MONTGOMERY COUNTY PLANNING DEPARTMENT
THE MARYLAND-NATIONAL CAPITAL PARK AND PLANNING COMMISSION

MEMORANDUM

REVIEW TYPE: Preliminary Plan of Subdivision and Preliminary/Final Water Quality Plan

PROJECT NAME: Muncaster Manor
CASE #: 120090190
REVIEW BASIS: Chapter 50, Montgomery County Subdivision Regulations

Figure 2: Preliminary Plan

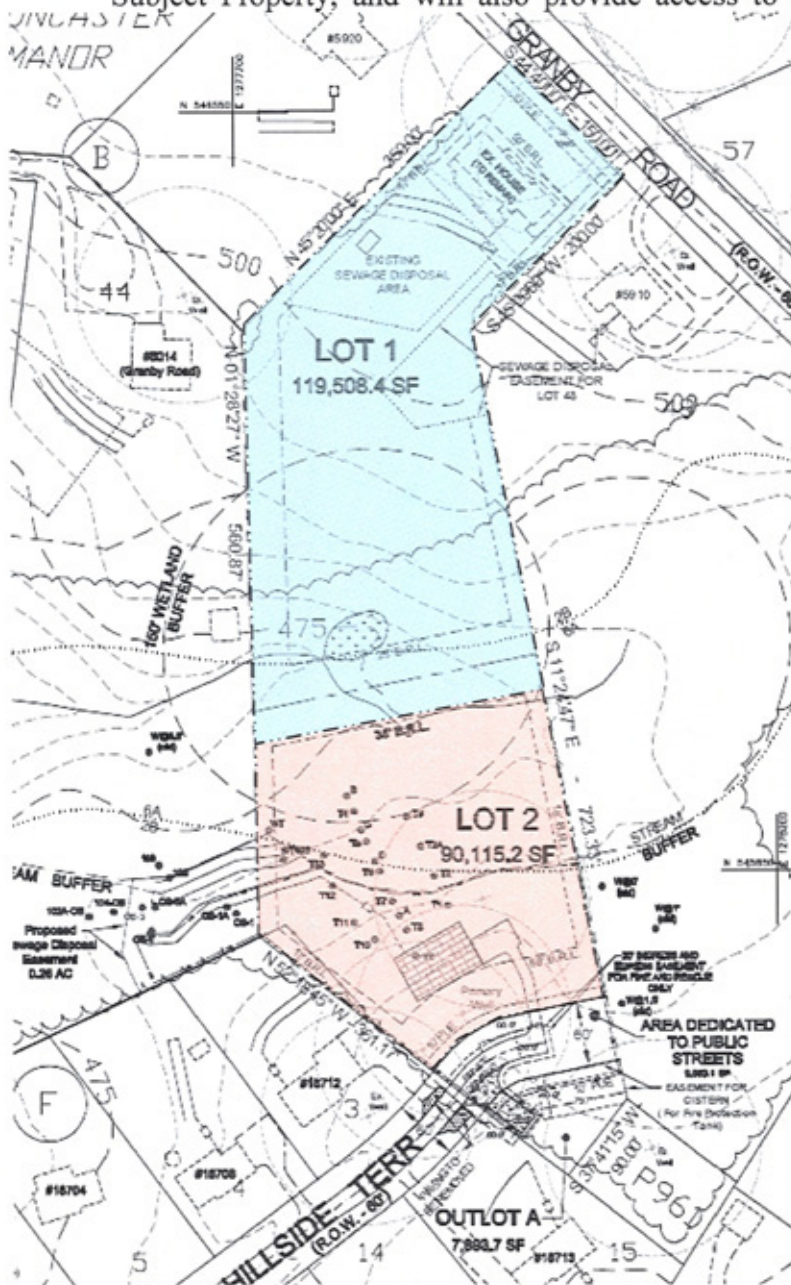
Proposed lot 1 fronts Granby Road, a secondary residential street requiring 60 feet of right-of-way. As delineated on the preliminary plan, the right-of-way is adequate along the frontage of proposed lot 1 and no additional dedication is necessary. Proposed lot 2 fronts Hillside Terrace, also a secondary residential street, which terminates at the Subject Property in a substandard manner and must be extended and properly terminated according to MCDOT requirements, as discussed in the Project Description section of this report. Staff and MCDOT considered whether to terminate Hillside Terrace and construct a cul-de-sac on the Subject Property, but both agencies found that additional development on adjacent properties may be possible, and a cul-de-sac located north of the site will have fewer impacts on the nearby environmental buffers. Sidewalks are not required in the RE-1 zone because pedestrians can safely use the roadway in such a low-density situation. Proposed vehicle and pedestrian access for the subdivision will be safe and adequate with the proposed public and private improvements. The addition of one new lot generates less than 3 new peak-hour vehicle trips, so the application is not subject to either Local Area Transportation or Policy Area Mobility reviews.

The two lots will be served by private, standard septic systems and wells. A 10-foot public utility easement has been provided along the frontage of both lots to accommodate any necessary installation of electrical and telecommunication services. The application meets the Montgomery County Fire and Rescue Service requirements for fire and rescue vehicle access and this application includes providing an easement for the possible construction of a cistern to enhance water supply to the area. Area schools are operating at adequate levels; therefore, the Subject Property is not within a school moratorium area and no facilities payment is required. Other public facilities and services, such as police stations, firehouses and health services, are operating within the standards set by the Growth Policy Resolution currently in effect. Gas, electrical and telecommunications services are also available to serve the lots.

- 5) The applicant must dedicate and show on the record plat approximately 9,563 square feet for a 60 foot-wide right-of-way for the extension of Hillside Terrace to the eastern property line of Lot 2 as shown on the approved preliminary plan.

- 6) The applicant must construct all road improvements within the rights-of-way shown on the approved preliminary plan to the design standards imposed by all applicable road codes.

Figure 3: Resubdivision Neighborhood Map

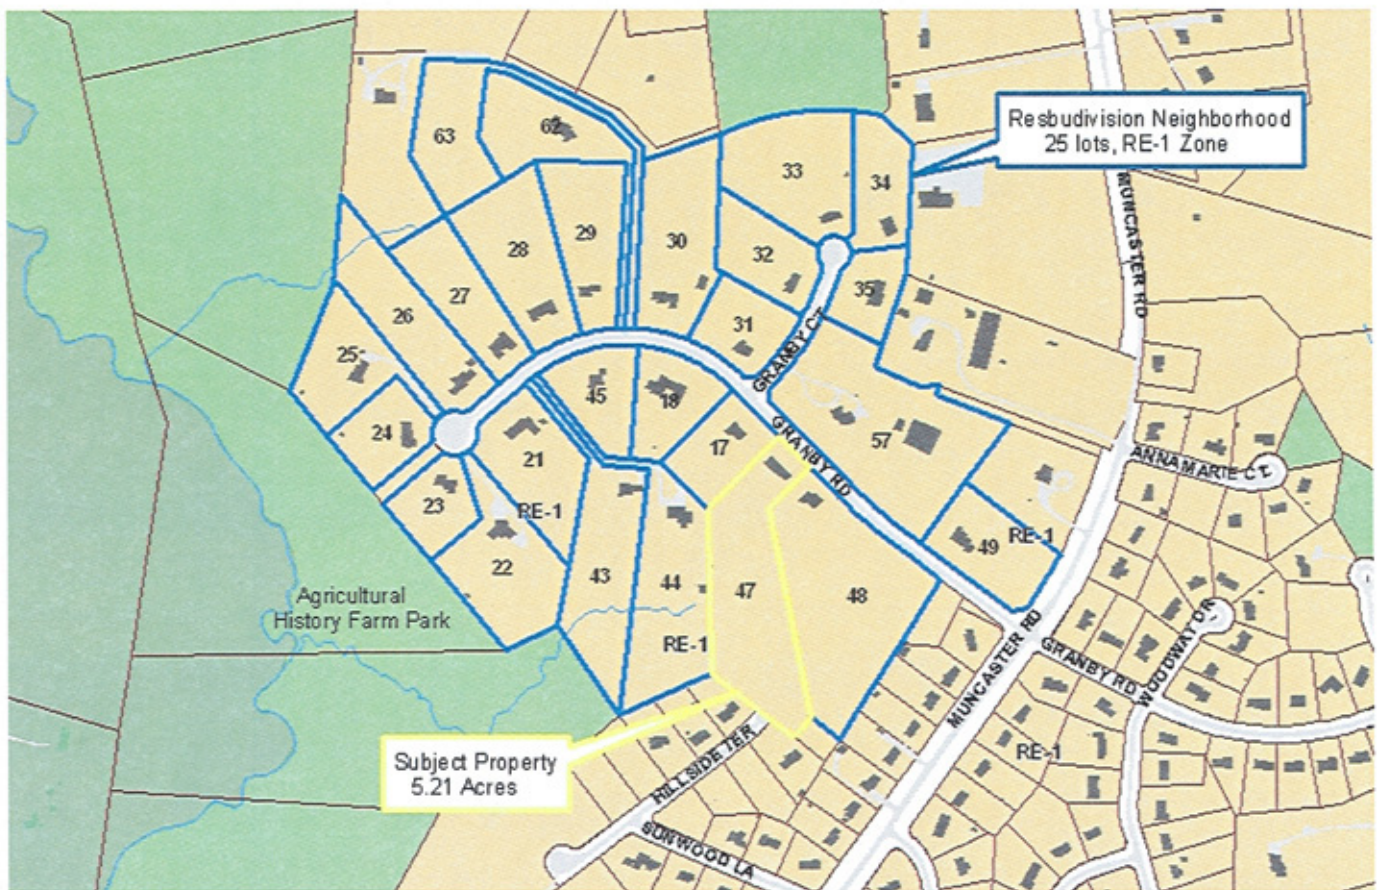
In performing the analysis, the above-noted resubdivision criteria were applied to the delineated neighborhood. The proposed lots are of the same character with respect to the resubdivision criteria as other lots within the defined Neighborhood. Therefore, the proposed resubdivision complies with the criteria of Section 50-29(b)(2). As set forth below, the tabular summary and graphical documentation support this conclusion:

In the 24 lot Neighborhood, lot frontages range from 25 feet to 1,063 feet. Nine lots in the Neighborhood have less than 100 feet of lot frontage and 15 lots have more than 100 feet of linear frontage at the street. Proposed lot 1 will have 150 feet of lot frontage and proposed lot 2 will have 181 feet of lot frontage. **The proposed lots will be of the same character as existing lots in the neighborhood with respect to lot frontage.**

Alignment: Fourteen lots in the designated Neighborhood are radial in alignment to the street, 7 lots are perpendicular and 3 lots are corner lots. The alignment of both proposed lots to the street will be perpendicular. **The proposed lots are of the same character as existing lots with respect to the alignment criterion.**

Lot sizes in the selected Neighborhood range from 61,898 square feet to 300,929.5 square feet, with 7 existing lots being less than 90,000 square feet in size. The proposed lot sizes fall within this range, with lot 1 consisting of 90,115 square feet and lot 2 containing 119,508.4 square feet. **The proposed lot sizes are in character with the size of existing lots in the Neighborhood.**

There are 2 triangular-shaped lots, 3 rectangular lots, 5 trapezoid-shaped lots, 9 irregularly-shaped lots and 5 pipestems in the 24 lot Neighborhood. **The shapes of the two proposed lots are both irregular and will, therefore, be in character with shapes of the existing lots.**

Lot widths at the building line within the Neighborhood range from 126 feet to 361 feet. Proposed lot 1 will be 150 feet wide and proposed lot 2 will be 266 feet wide at the building line. **The proposed lots will be in character with existing lots in the Neighborhood with respect to width.**
